Contract No. T200911302.01  
Federal Aid Project No. NH-2015(22)  
US 301 & SR 1 Interchange  
New Castle County

Enclosed is Addendum No. 2 for the referenced contract consisting of the following:

US 301 & SR 1 INTERCHANGE

<b>PN-02</b>
SHEET NO.
7
TOTAL SHTS.
491

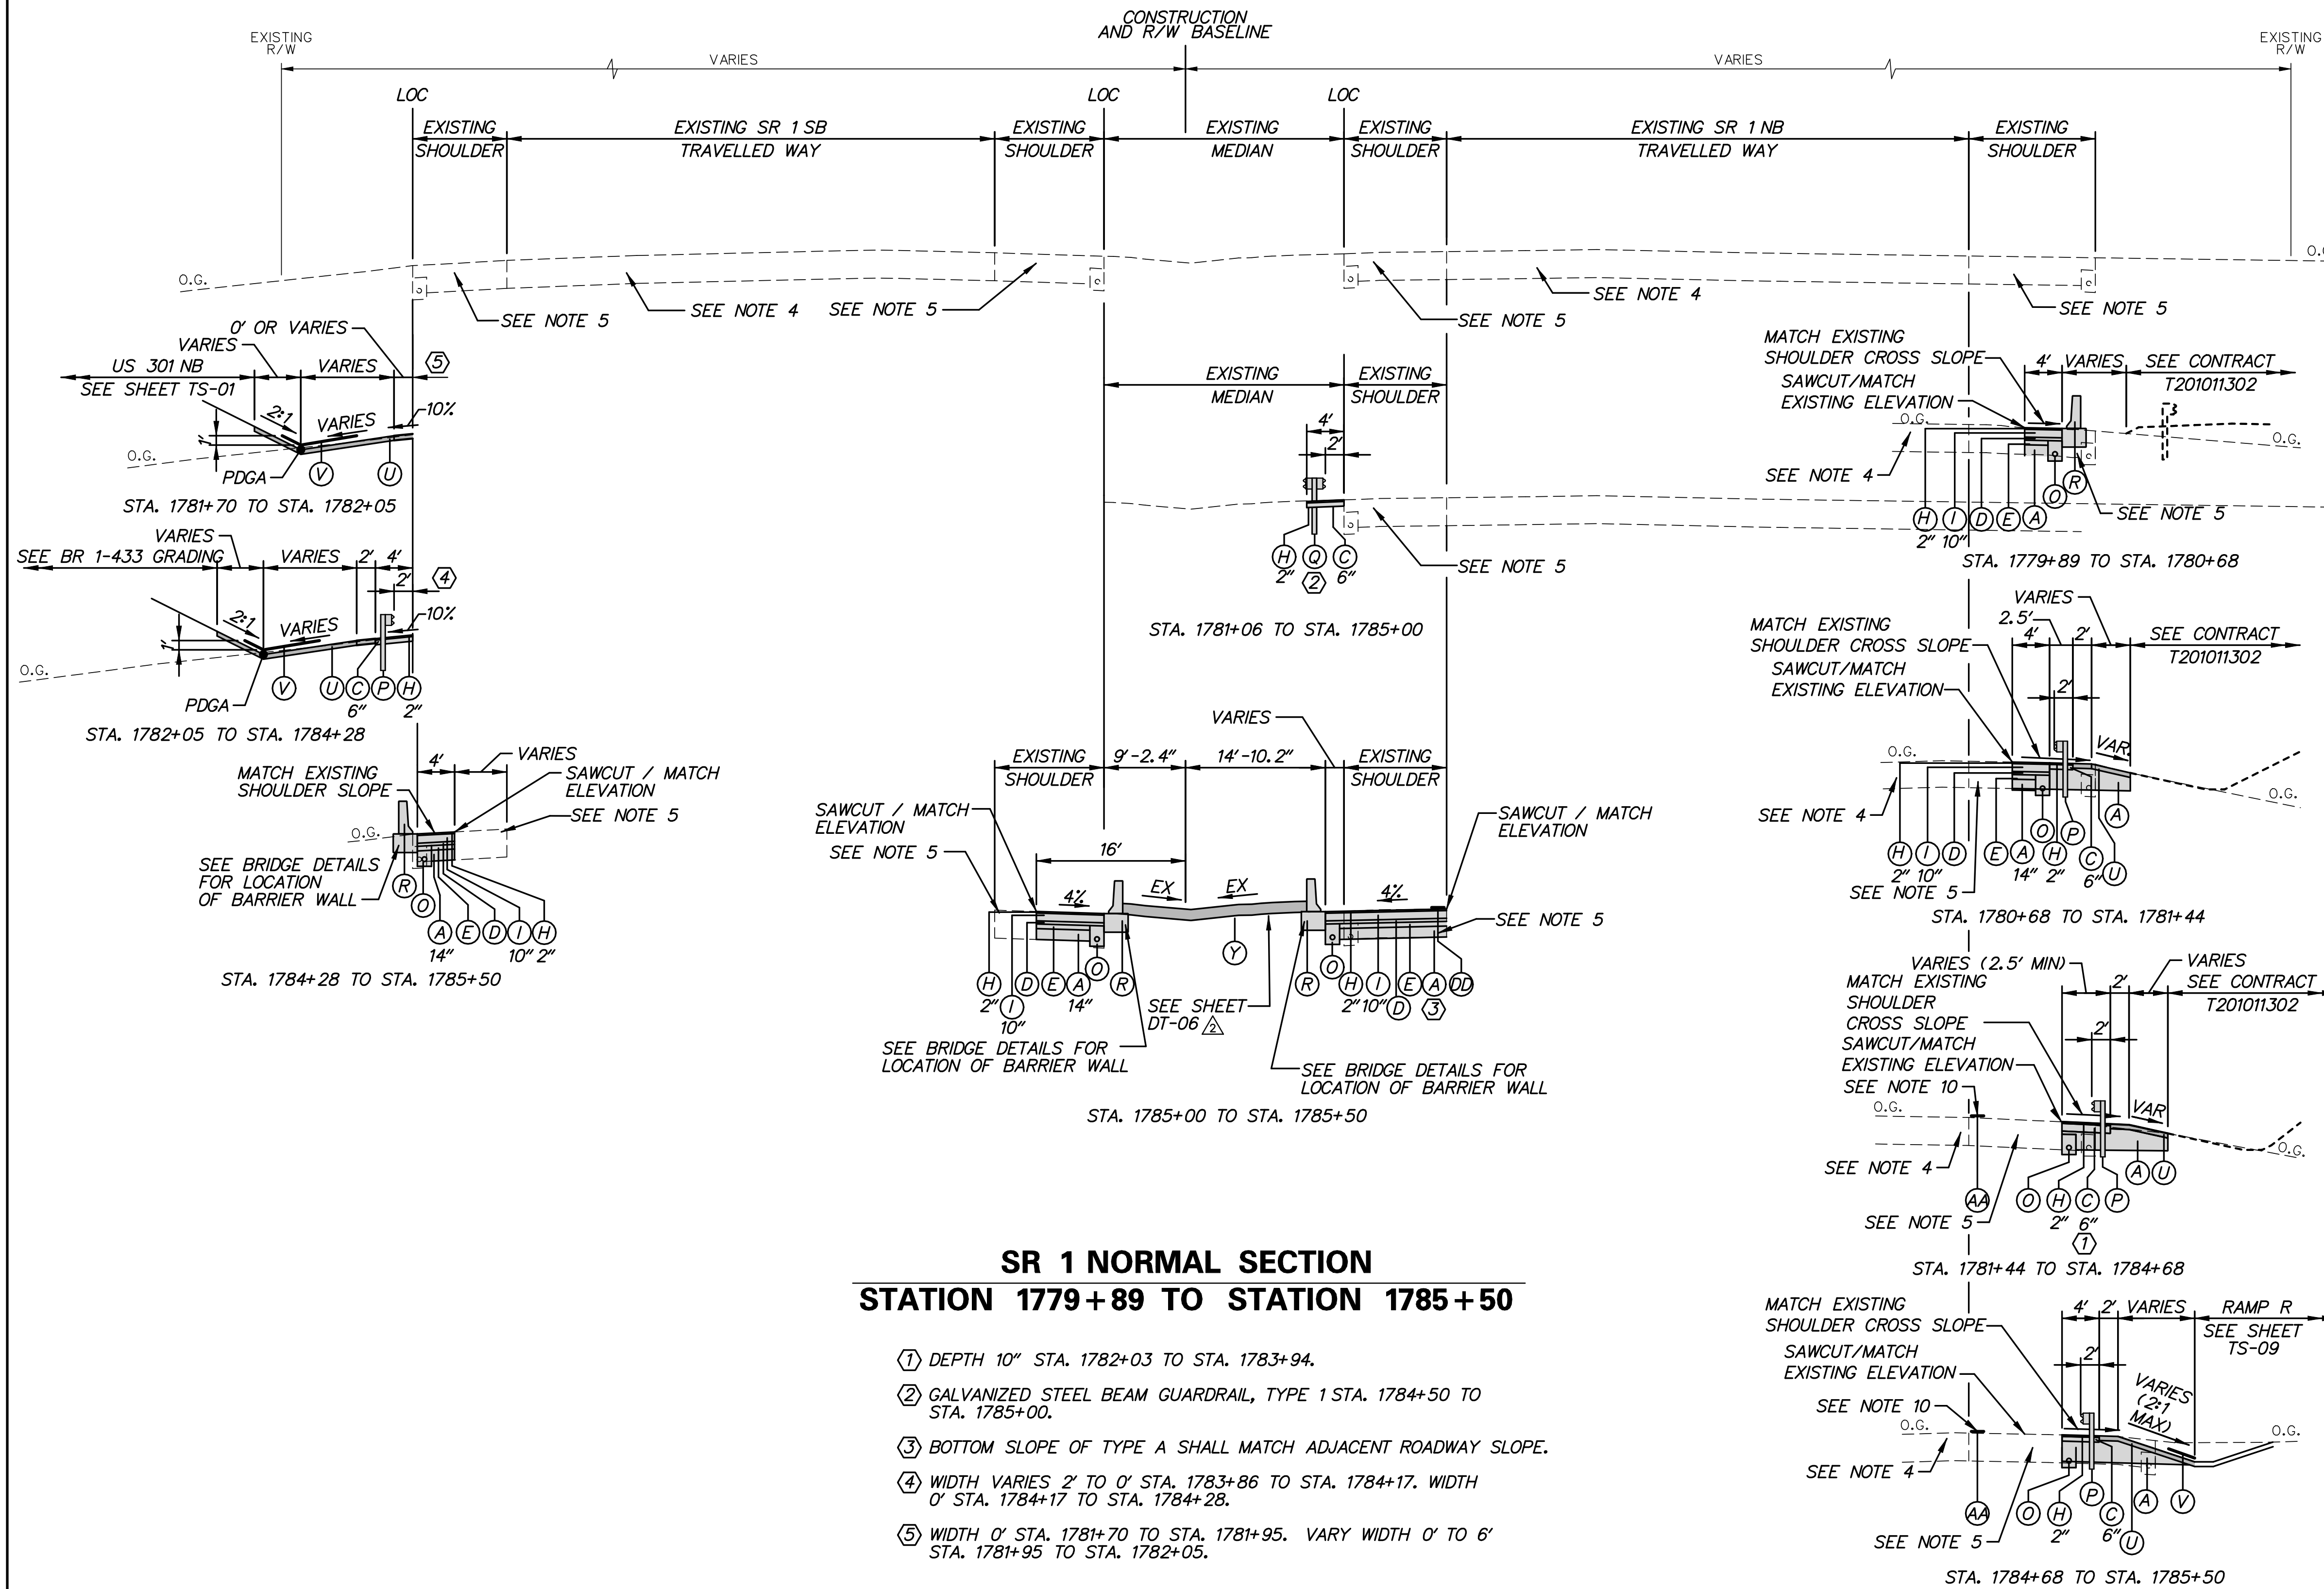
ADDENDUMS / REVISIONS	
△	REVISED NOTE: BRT/DMG

SHEET NO.	23
TOTAL SHTS.	491

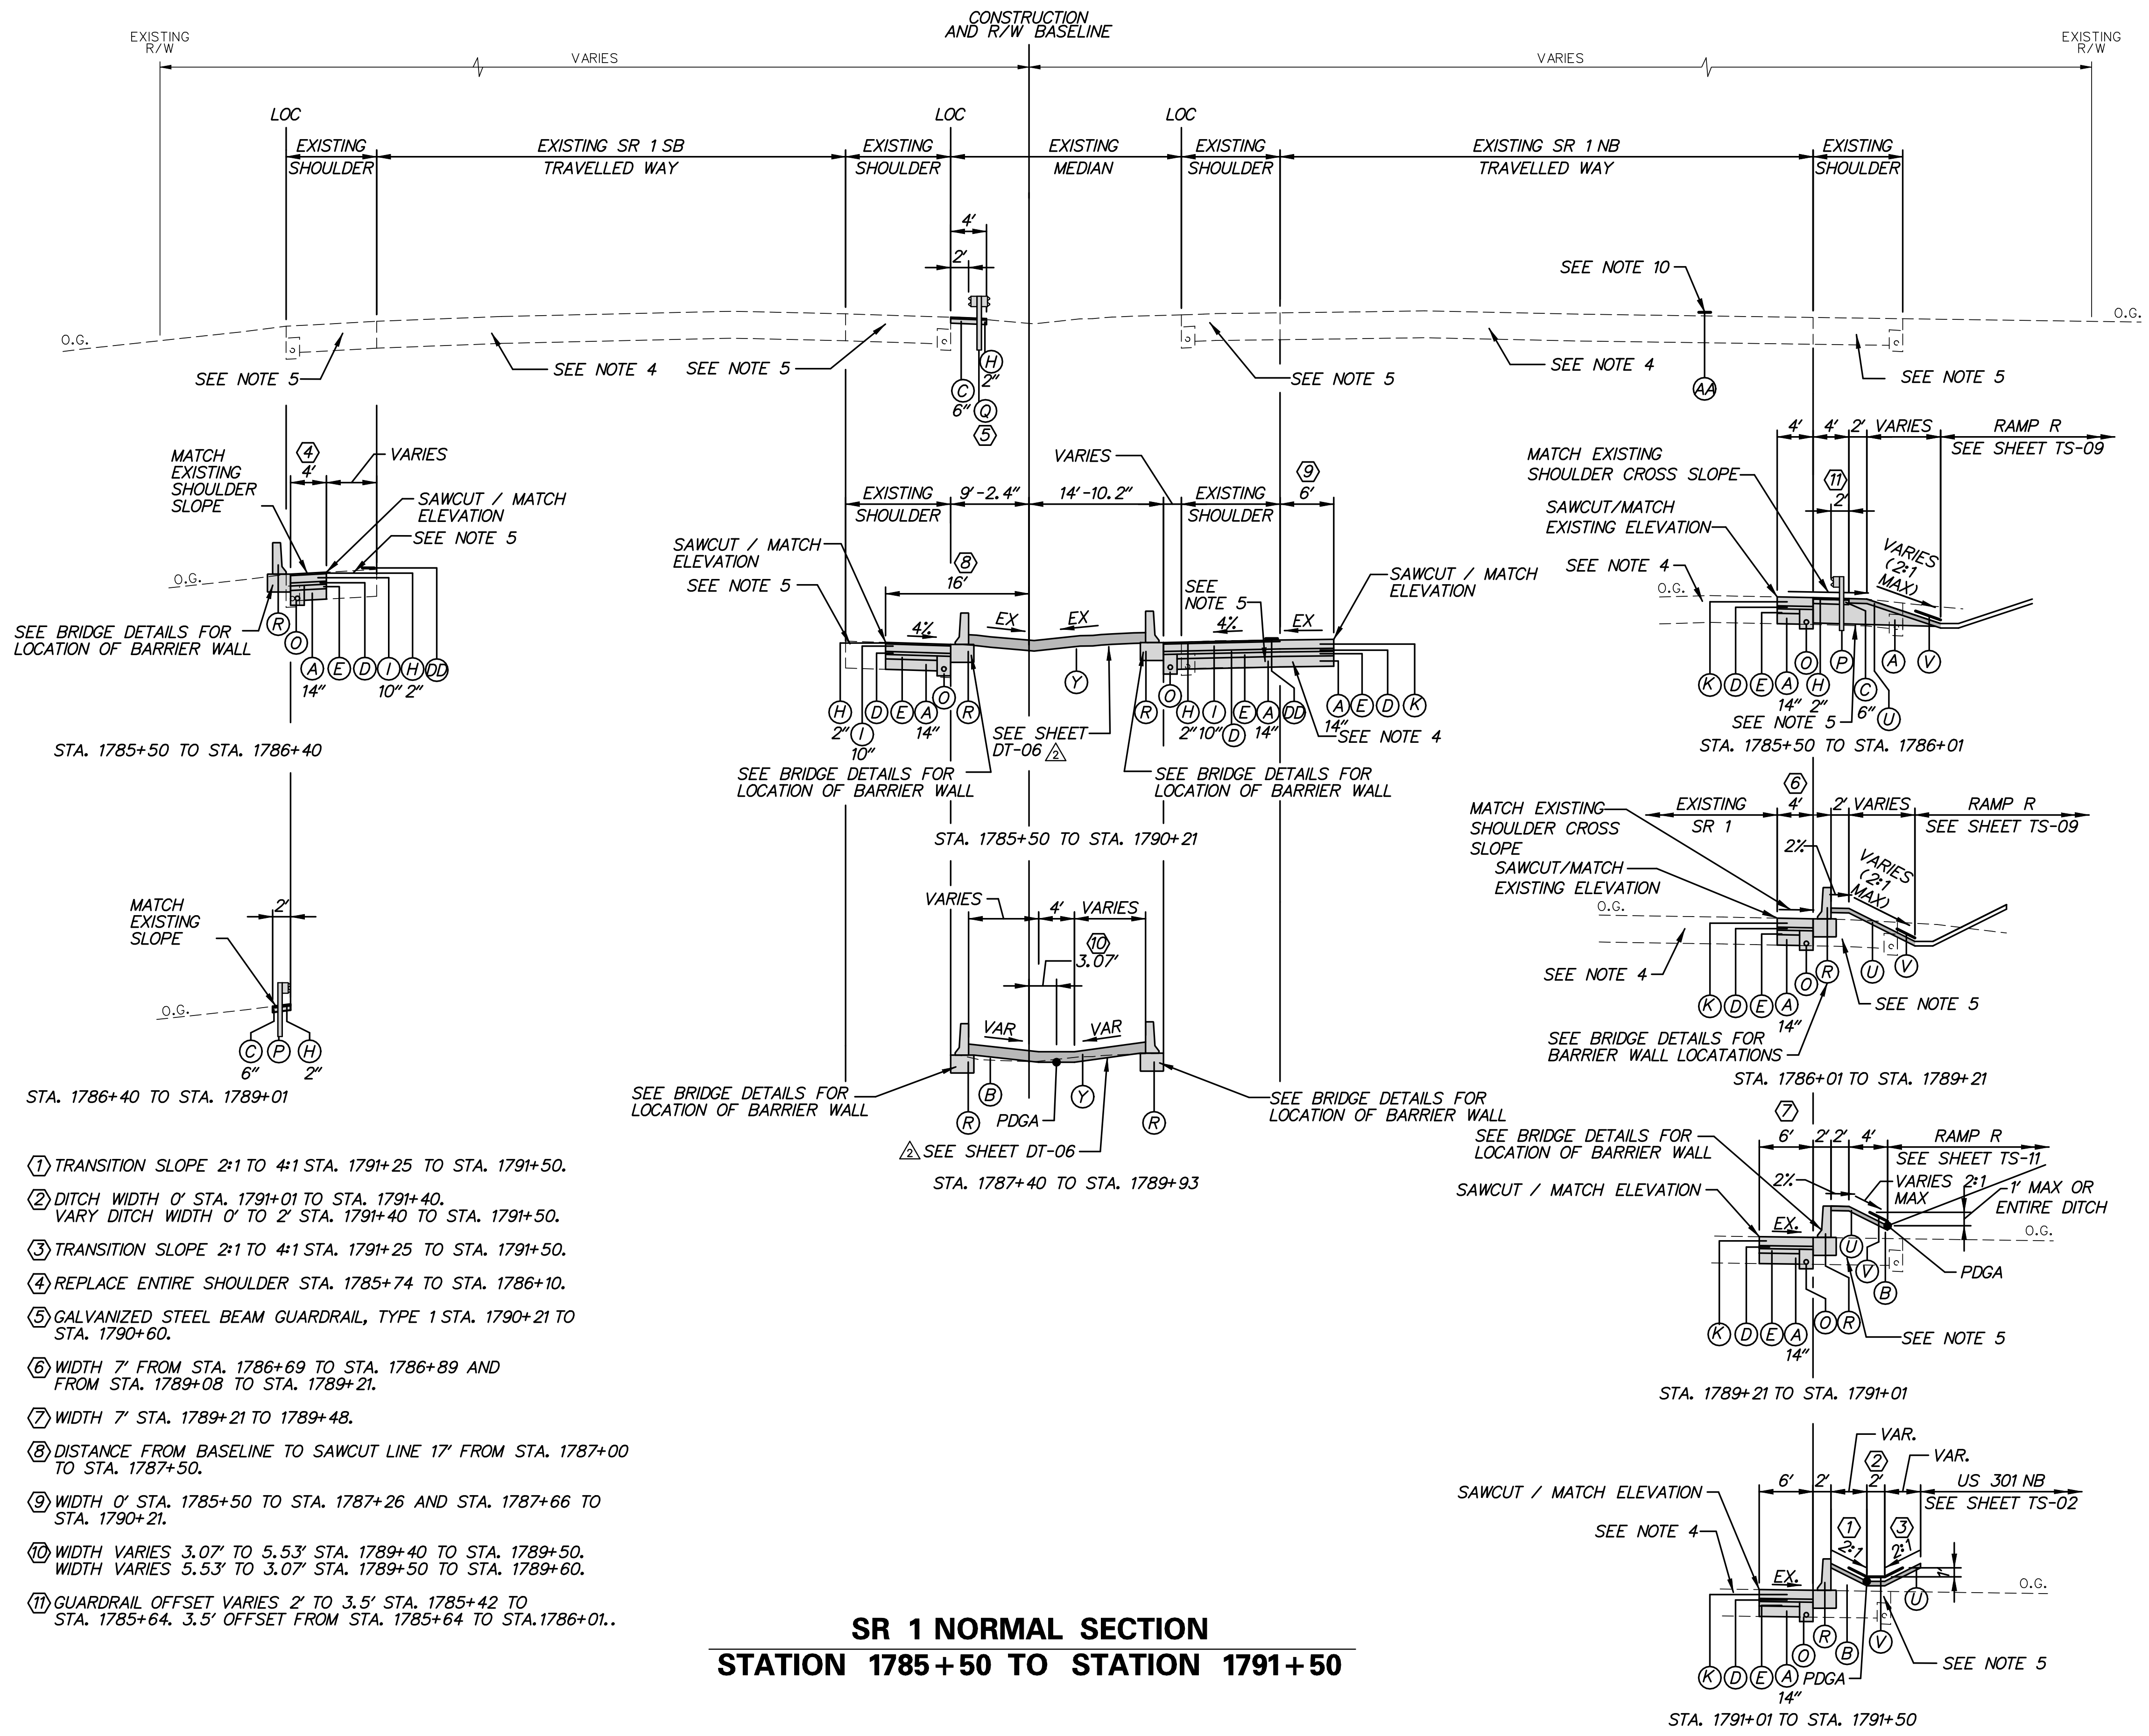
ADDENDUMS / REVISIONS	
△ REVISED CROSS-REFERENCE: BRT/DMG
